# Received Signal Level at Globalstar Terminal for RF Lighting Devices and Equivalent Microwave Ovens

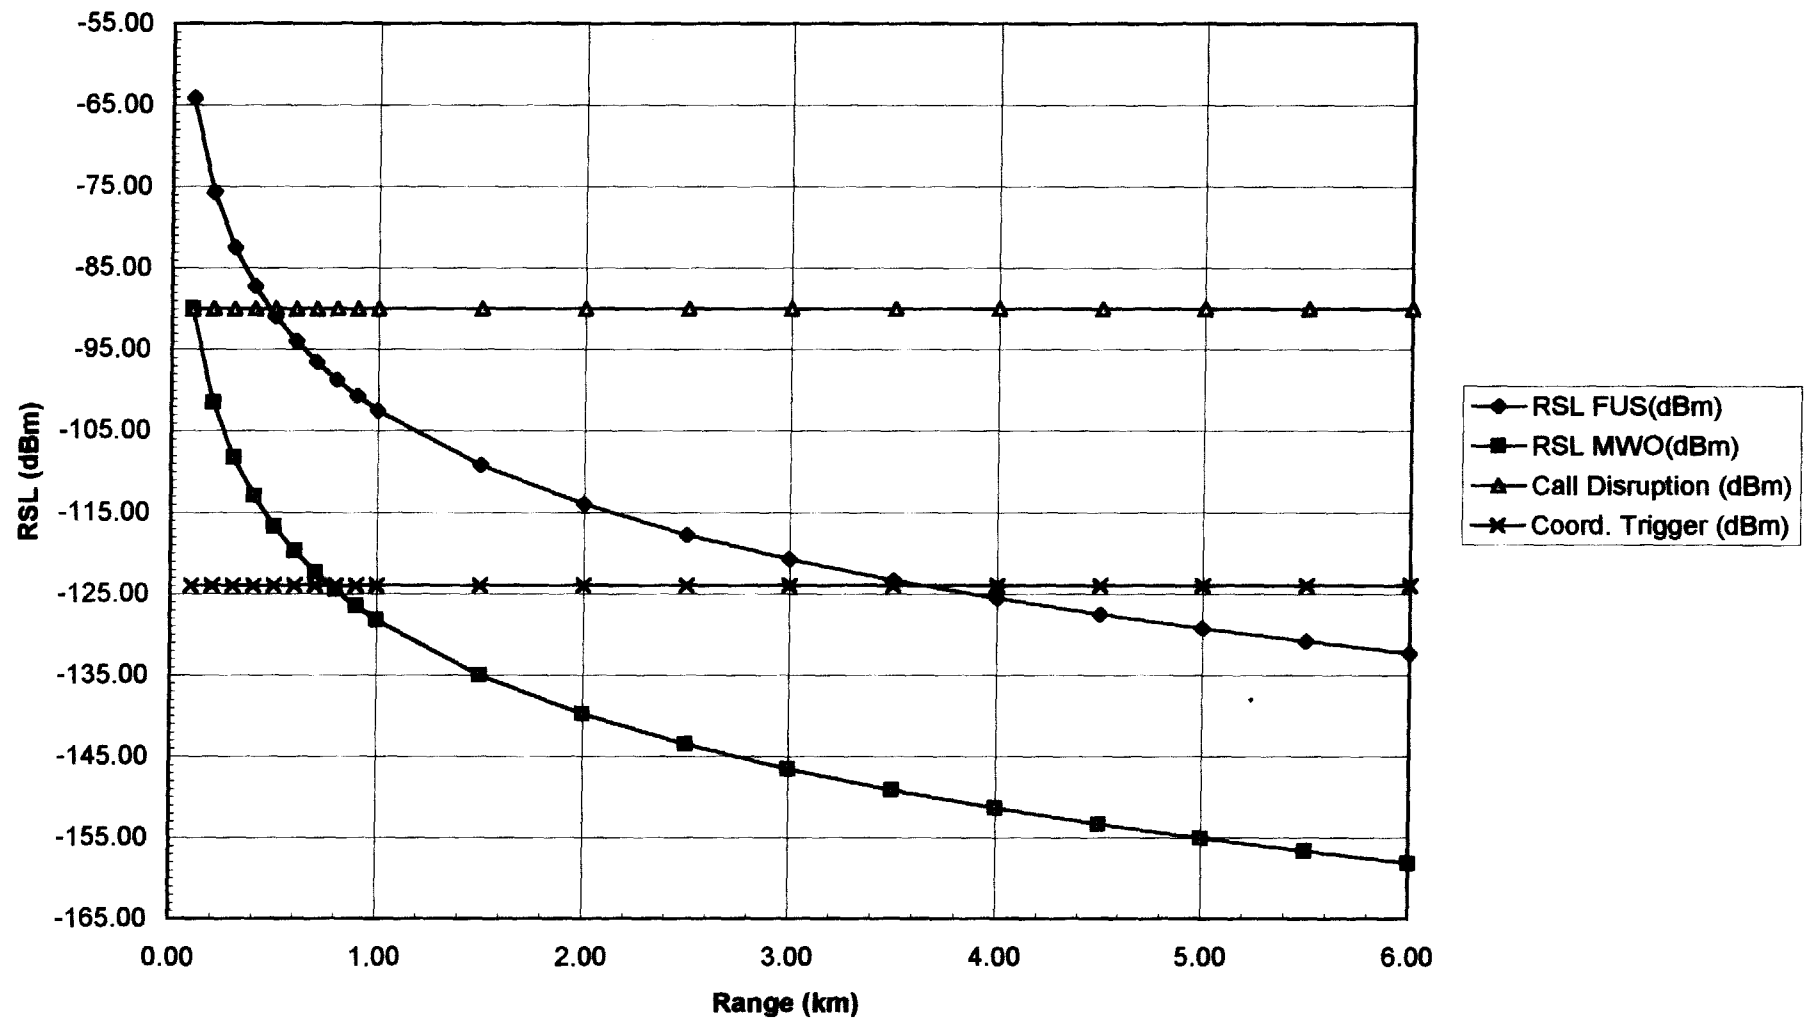
Two curves are shown in the accompanying Figure. The upper curve shows the Received Signal Level (RSL) in dBm, at a Globalstar user terminal, for an RF lighting device with a microwave power output of 15 watts. These points are labeled "RSL FUS(dBm)." The lower curve shows the RSL at a Globalstar user terminal assuming that the RF lighting device had an output power equivalent to a microwave oven operating continuously indoors and in compliance with the radiation guidelines of the U.S. Food and Drug Administration of 5 milliwatts per square centimeter, 5 centimeters from the oven. These points are labeled "RSL MWO(dBm)." One notes that the RSL at the Globalstar user terminal is consistently 25.8 dB lower for the equivalent microwave oven than for the RF lighting device. In the Addendum to The Mobile Satellite Service (MSS) Above 1 GHz Negotiated Rulemaking Committee Report (April 6, 1993), dealing with Sharing with Services Other than ARNS and RAS, it was indicated that a building shielding loss, that is effectively the difference between continuously operating microwave oven indoors or outdoors, of 16 dB was suitable when determining the potential interference to the Mobile Satellite Service. This 16 dB loss has been included in the calculation of the lower curve. An additional factor that has not been included in the lower curve in the accompanying Figure is the equivalent loss due to the microwave oven activity. Microwave ovens unlike microwave lighting

6. The International Telecommunications Union (ITU) considers interference that produces an increase in receiver noise level of 6% to be a trigger for coordination between the interfering party and the interfered with party. This is equivalent to an interfering signal 12 dB below the noise level of the Globalstar user terminal receiver. The Globalstar user terminal receiver noise level is -112 dBm thus interference corresponding to the coordination trigger level would be -124 dBm. From the accompanying Figure it is apparent that a Globalstar user terminal would have to be at least 4 kilometers from a Fusion RF lighting device in order for the interference to be below the ITU coordination trigger level.

7. A Field Strength Limit of 100 microvolts per meter is proposed in the instant NPRM for radiated emissions from RF lighting devices outside of the band 2450+/- 50 MHz. The imposition of this limit in the 2483.5 - 2500 MHz band which is allocated to the Mobile Satellite Service would provide protection for Globalstar user terminals that would be exposed to radiation from microwave lighting devices. If a microwave lighting device met the 100 microvolt per meter limit, the microwave emissions would correspond to those coming from an isotropic source of 0.3 microwatts (-35.2 dBm). Assuming free space propagation loss, a Globalstar user terminal would have to be less than 6 meters from the lighting device before calls

would be interrupted. If a Globalstar user terminal operated 36 meters or more from a microwave lighting device meeting the 100 microvolt per meter limit, the lighting device radiation would be below the ITU interference coordination limit of -124 dBm, assuming that the Hata propagation model applied. A radiated field strength limit applied over the 2483.5-2500 MHz band is thus needed to provide protection to Globalstar user terminals.
